TEXAS COMMISSION ON ENVIRONMENTAL QUALITY

Subject: Texas Disposal Systems Landfill - Travis County
Municipal Solid Waste - Permit No. 2123
Permit Modification - Technical Review Completed
Tracking No. 28105718; RN102016698/CN600126932

Narrative of Proposed Modification

GRADING PLAN - COMBINED SURFACES
 PERMIT MODIFICATION
 TEXAS DISPOSAL SYSTEMS LANDFILL

Attachment 9-6.1.b.
Phases I, II and III
Cross Sections

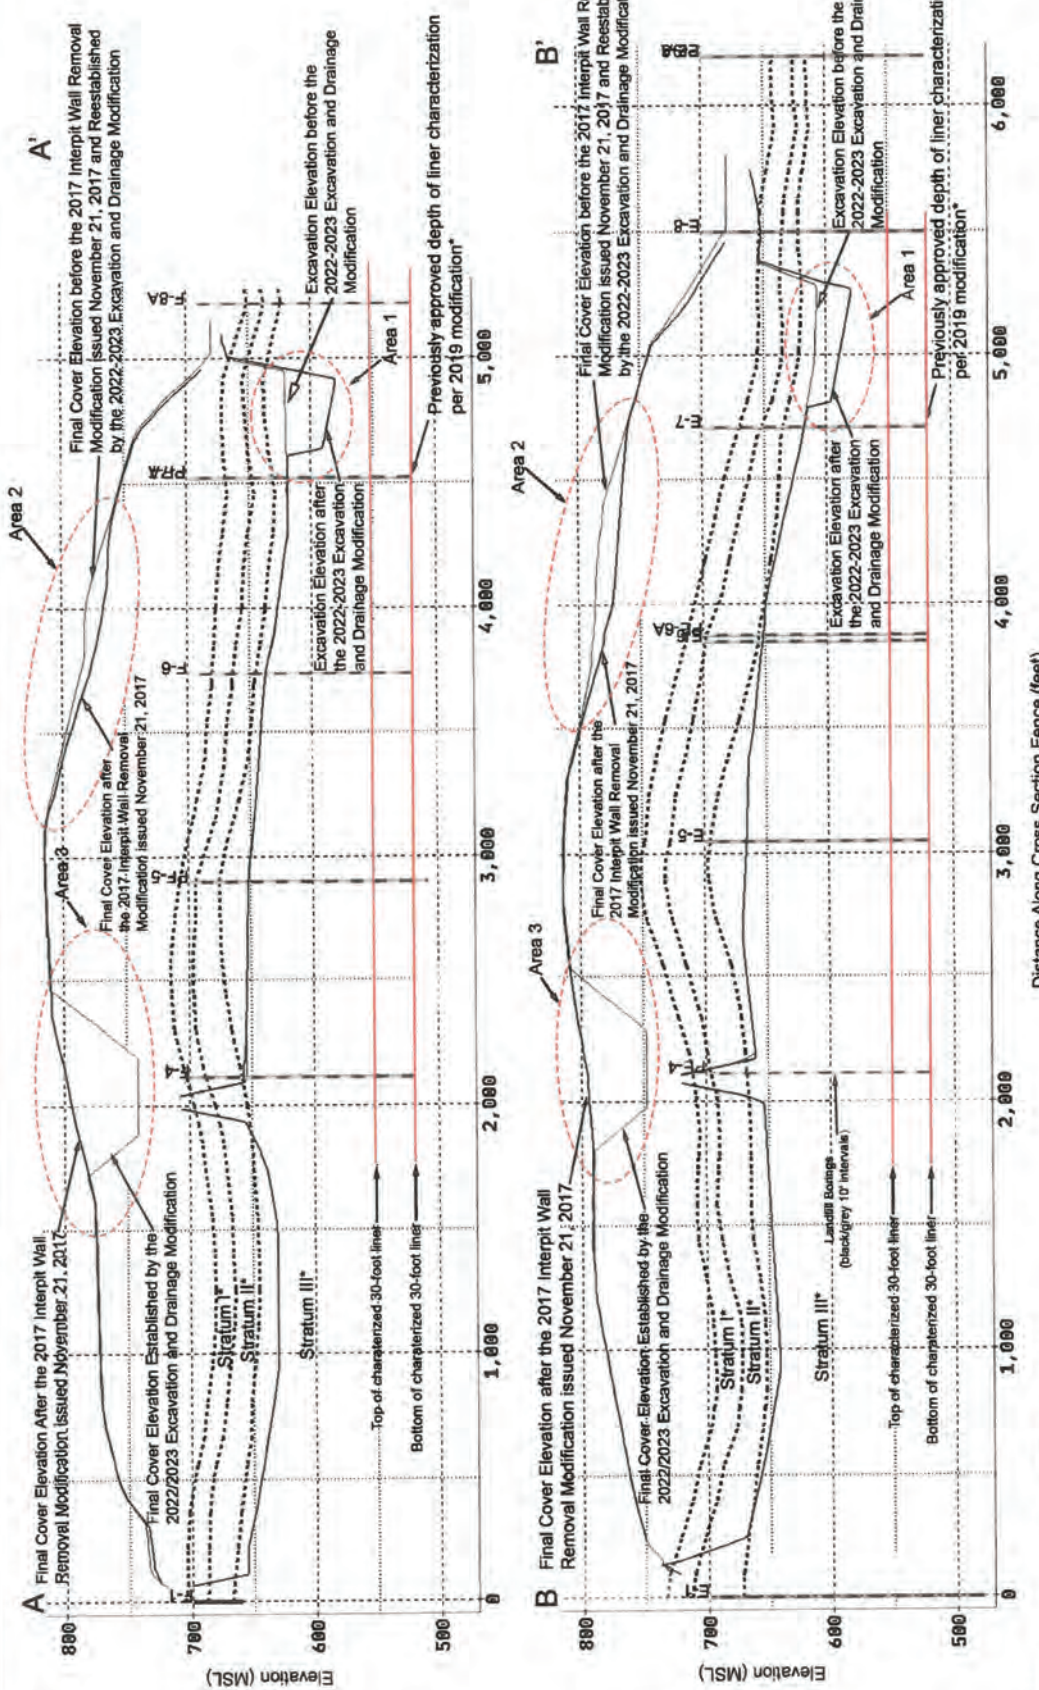
The final cover contours have been modified in two areas as depicted on the Attachment 9-6-1.b Cross Sections. The final cover contours over the area connecting Phase II and Phase III have been elevated slightly to return to its originally permitted elevation prior to the

'2017 Permit Modification for Removal of Interpit Wall Between Phases II and III and Readjustment of Final Cover Elevations to Result in a no Net Gain in Landfill Volume' resulting in a waste capacity increase of 522,137 cubic yards. To offset these capacity surpluses and to maintain access to the western portion of the permit boundary, the final cover contours along Ditch A between Phase I and Phase II have been modified (lowered) resulting in an overall net decrease in waste capacity of 1,332,178 cubic yards for no net gain in landfill volume waste capacity resulting from this modification.

- Three areas identified for modification (depicted by dash red lines) to result in no net gain in Landfill Volume:
- Area 1 - Modification of design within Phase III (Total Volume Addition 810,041 cubic yards)
- Area 2 - Modification of design over Phases I/II to its originally permitted design prior to the 2017 Permit Modification for Removal of Intercept Wall Between Phases II and III and Readjustment of Final Cover Elevations to Result in a no Net Gain in Landfill Volume (Total Volume Addition 522,137 cubic yards)
- Area 3 - Modification of design over Phases I/II (over Ditch A) (Total Volume Reduction 1,332,178 cubic yards)
- Stratum definitions, boring plan, and liner characterization as approved per Subchapter J Groundwater Monitoring Permit Modification (See Executive Summary page II, last paragraph), February 25, 2019.

Three areas are identified for modification (depicted by dash lines with labels that mark and enclose Areas 1, 2, and 3 on the cross sections depicted in Attachment 9-6.1.b.) to result in no net gain in Landfill Volume. Calculations were performed using *AutoCAD Civil 3D*.

Area 1 – Modification of design within Phase III (Total Volume Addition 810,041 cubic yards).

Area 2 – Modification of design over Phases II/III to its originally permitted design prior to the '2017 Permit Modification for Removal of Interpit Wall Between Phases II and III and Readjustment of Final Cover Elevations to Result in a no Net Gain in Landfill Volume' (Total Volume Addition 522,137 cubic yards).

Area 3 – Modification of design over Phases I/II (over Ditch A) (Total Volume Reduction 1,332,178 cubic yards).

Appendix D
 Land Ownership Map
 1/4 Mile from the Facility Boundary
 Texas Disposal Systems Landfill, Inc.
 Texas Disposal Systems Landfill
 Project No. 2123A
 Date: Revised 08/25/2023

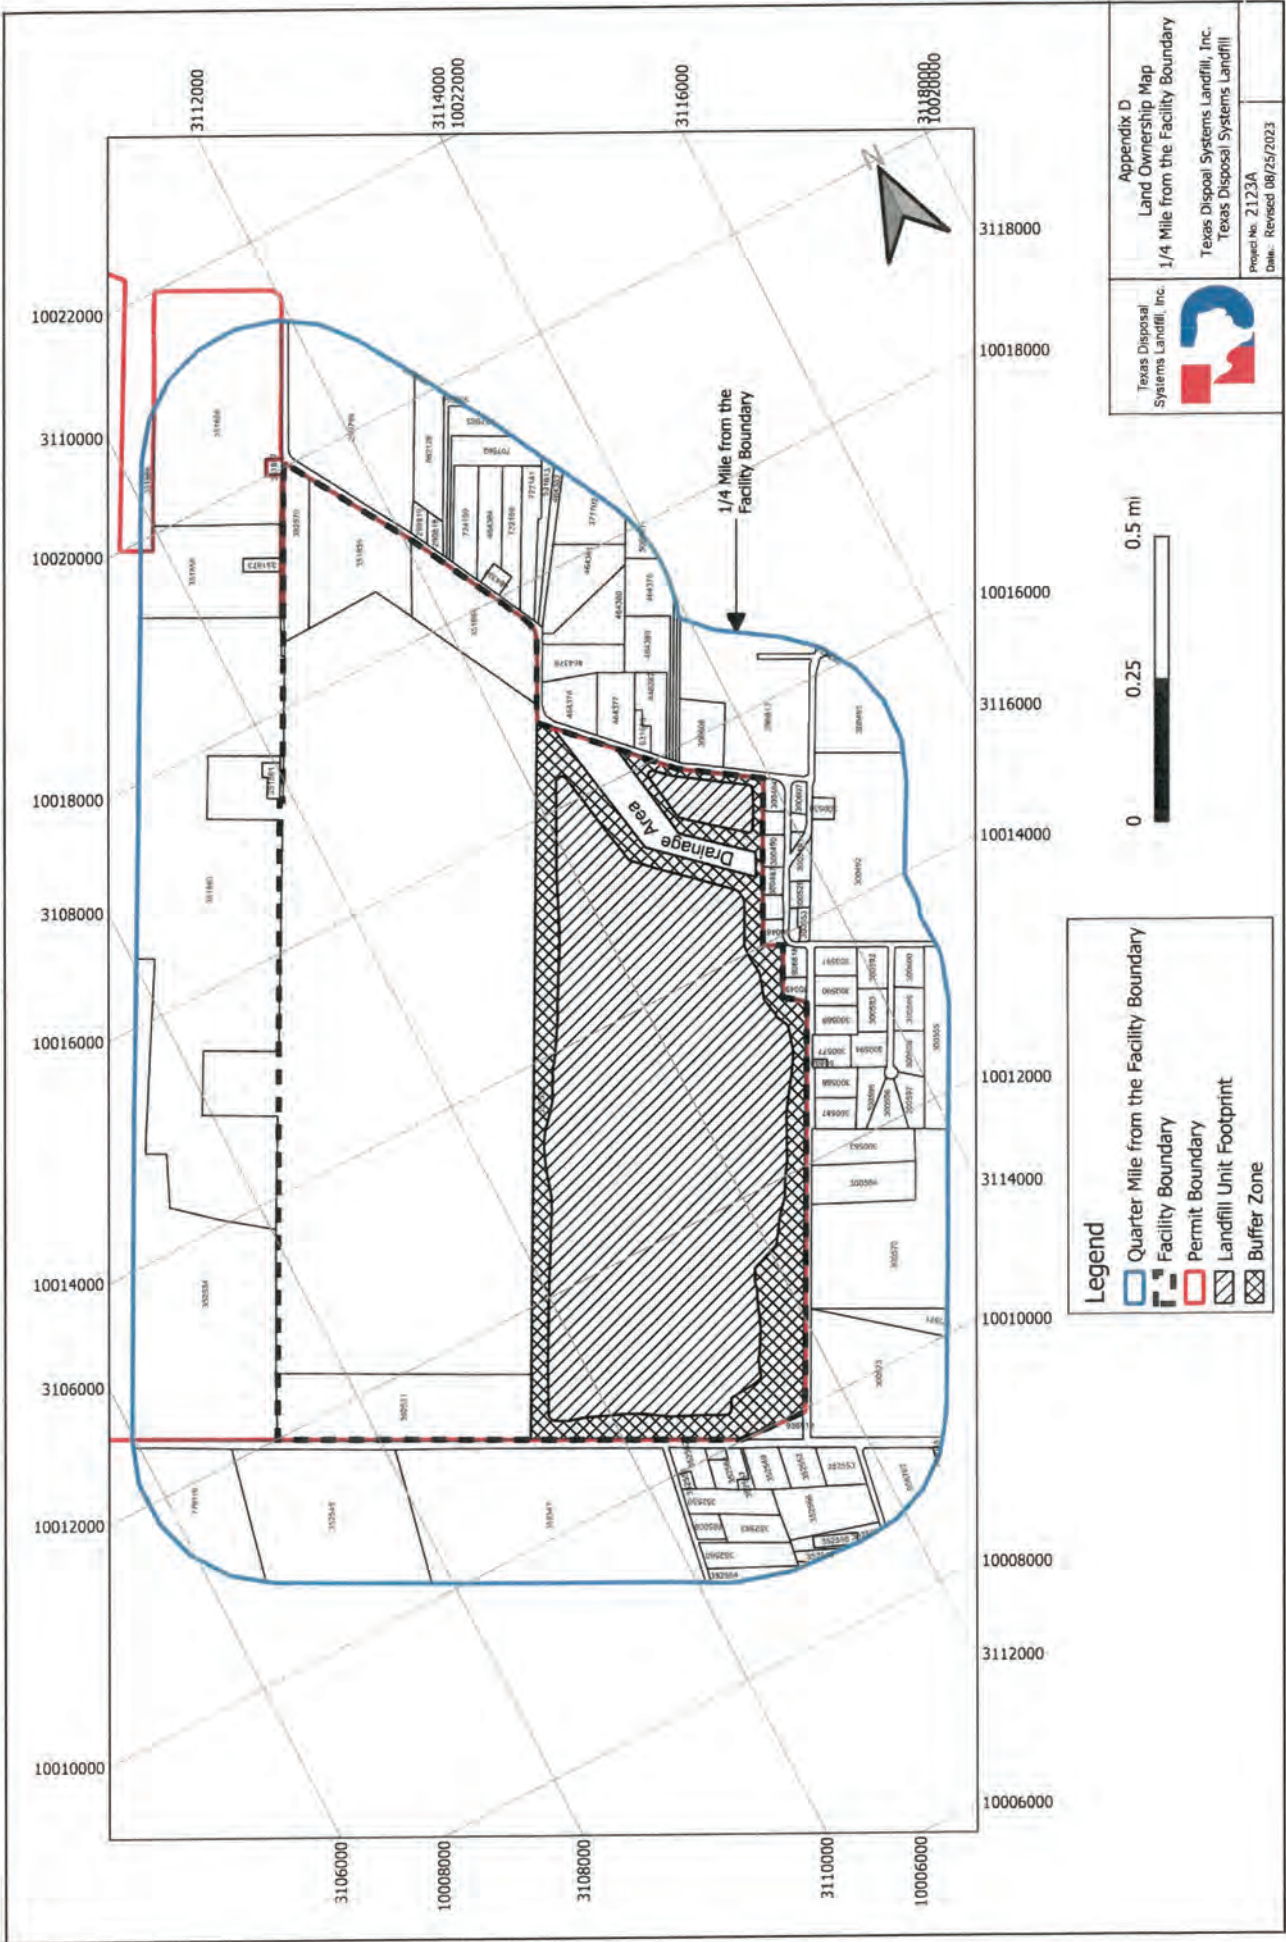
The facility boundary map has been revised to expand the facility boundary within the permit boundary. This map is shown in Appendix D. The 2019 buffer zone modification issued December 30, 2019 laterally expanded the permit boundary, and as such, the permit boundary was appropriate to use for notification purposes. 30 Tex. Admin. Code Section 330.59(c)(3)(A) requires the land ownership map to “show all property ownership within ¼ mile of the facility, and all mineral interest ownership under the facility.” TCEQ defines the term “facility” as “all contiguous land and structures, other appurtenances, and improvements on the land used for the storage, processing, or disposal of solid waste.” 30 Tex. Admin. Code § 330.3(52); see also id. § 330.3(91) (definition of “municipal solid waste facility”).

After a review of this definition in conjunction with several other defined terms in TCEQ’s rules (including “municipal solid waste landfill unit,” “waste management unit boundary,” and “buffer zone”) and various provision of the Chapter 330 MSW rules, TDSL has redrawn the “facility boundary” to include not just the landfill footprint but also other structures, appurtenances, and improvements, including the composting operation and the appropriate buffer zones. This “facility boundary,” shown on Attachment D, is based on TCEQ’s definition of “facility” and incorporates all areas traditionally included within the facility boundary.

When the TDSL landfill permit area was expanded in 2019, it specifically identified that the vast majority of the area to the west of the then existing permitted landfill was for ancillary activities, not MSW processing or disposal. Because that area is not used for storage, processing, or disposal of solid waste, and because the entirety of the area is not necessary to meet the buffer zone requirements set out in the Chapter 330 rules, that area does not meet TCEQ’s definition of facility, and thus, is not included in the “facility boundary.”
